Amendments to the Drawing Figures:

REMARKS

Annotated Sheet

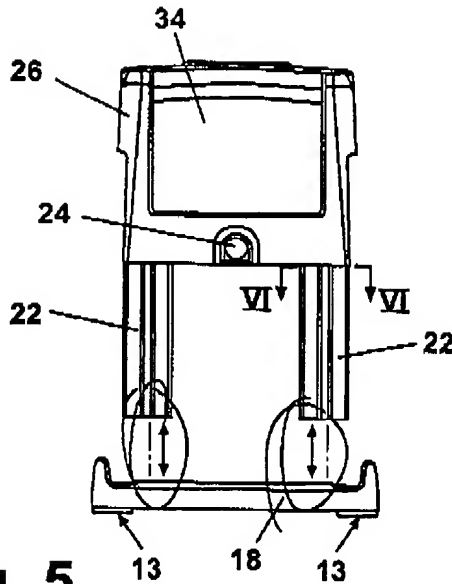
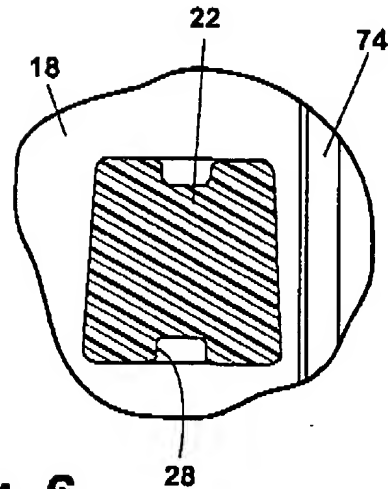
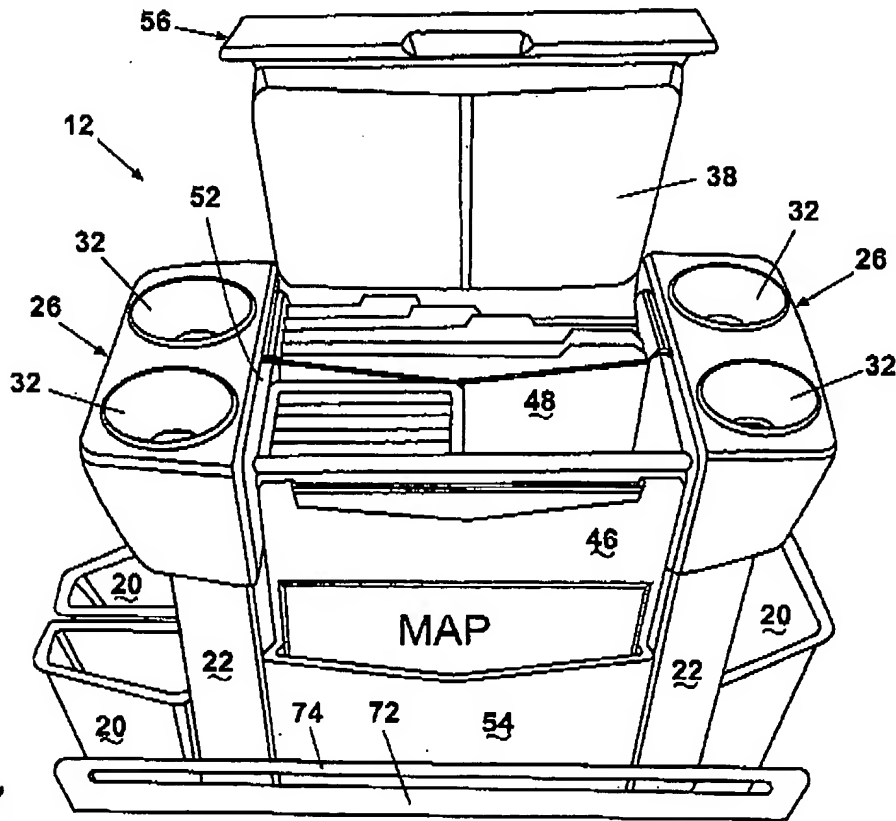
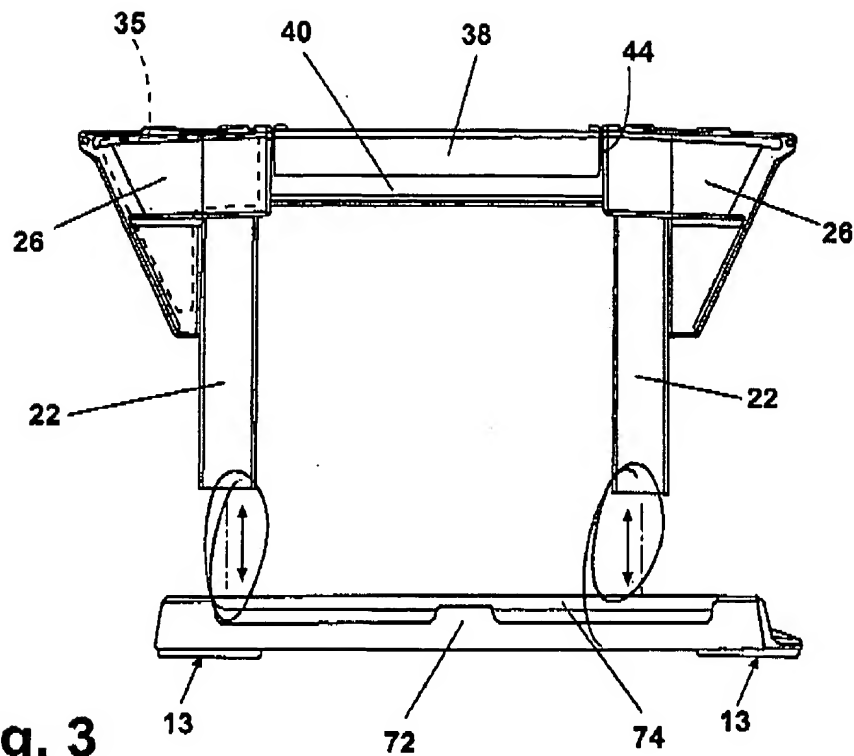
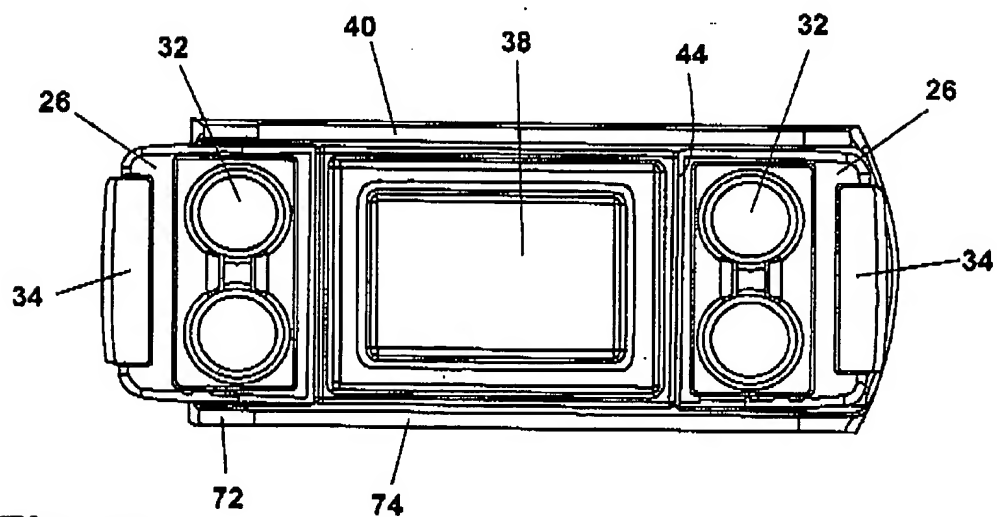
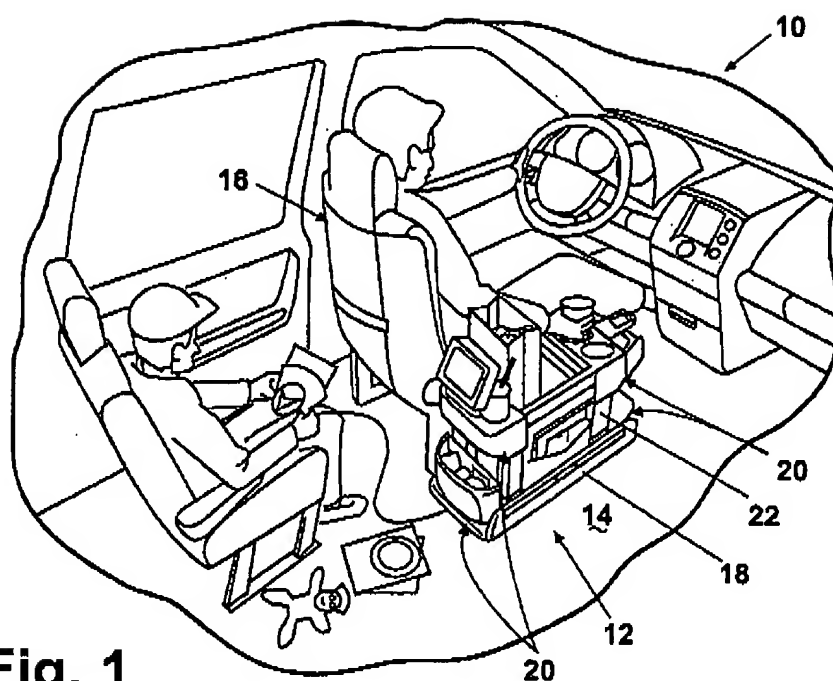
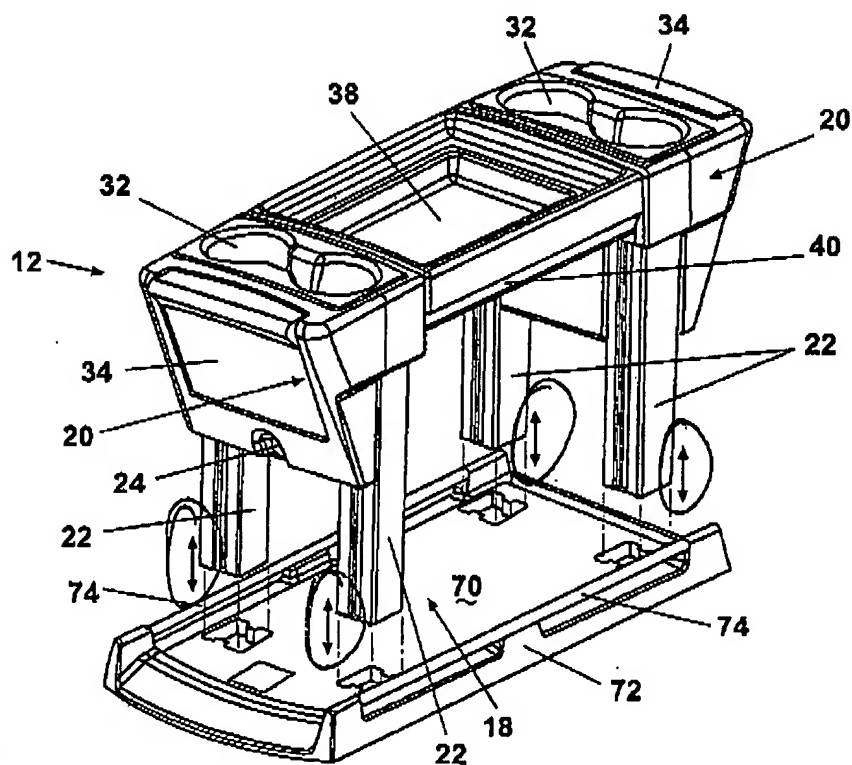
The drawing figures have been amended to reflect that the upright support assemblies properly identified by reference numeral 22 may be attached to the base tray assembly 18 in a first configuration and removed from the base tray assembly in a second configuration as recited in independent claim 1. Language of similar import is contained within independent claims 11, 14, 16, and 25.

The drawings were objected to because they failed to show the electrical socket was attached to a power supply of the vehicle, and that the framework assembly could be removed from the base assembly as claimed and described in the patent specification.

A set of drawing figures showing the proposed changes are attached with the proposed change enclosed within the circled regions.

The drawings have been amended as illustrated by the annotations accompanying this response. Moreover this issue has also been addressed by amending certain of the claims to

make the claim language consistent with the content of the drawing figures. In particular the claims citing a power socket or electrical supply have been cancelled or amended to remove the reference. The drawings have also been amended to reflect the modular nature of the invention consistent with the Examiner's earlier indication this feature, if placed in independent format, would place the application in condition for allowance.
